Proposal for Supplement 4 to the 07 series of amendments to Regulation No. 14 (Safety-belt anchorages)

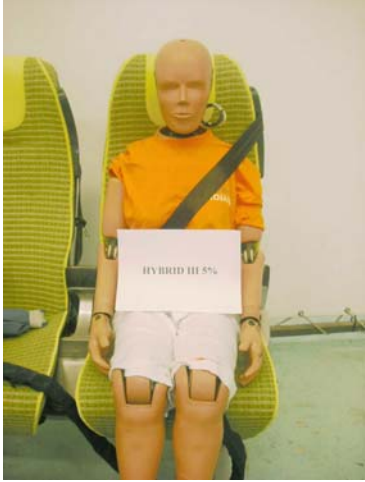
This system, created to be installed in bus seats, allocates automatically the upper anchorage safety belt in the level of the occupant's shoulder. The effective upper anchorage is over the level of C point (according to point 5.1.4 of UN ECE R14/07) if the occupant is an Hybrid III 5th percentile or higher. This system also allows to the upper safety belt anchorage to go below the C point, working safely with children of groups II and III according to UN ECE R44/04

Seats with a combined restraint systems adequate to restrain the children and the adults have appeared in the European market. In the children position these systems don't fulfil with the effective upper belt anchorage height requirements defined in

the Regulation No.14. This document demonstrates that is not a problem of safety of this systems and the modification proposed try to allow the approval of this systems to improve the safety of the children in vehicle M2 and M3.

- "5.4.3.8. In the case of a safety belts installed in vehicles category M2 and M3 and designed to restraint adult and children, the vehicle must fulfil the following conditions:**
- (a) The position of the upper belt effective anchorage must be permanently marked in the vehicle or seat to define the children position or the adult position.**
 - (b) The effective upper belt anchorage must fulfil the requirements of paragraph 5.4.3.1 to 5.4.3.6. in the adult conditions defined by the manufacturer. If movement of the height adjuster is automatic the checking of the provisions defined in the paragraph 5.4.3.1 to 5.4.3.6 will be performed with the 50% percentile HYBRID III dummie installed in the seat with the safety belt fastened.**
 - (c) The restraint system must be approved according to Regulation No.44.04 for the groups of masses defined by the manufacturer."**
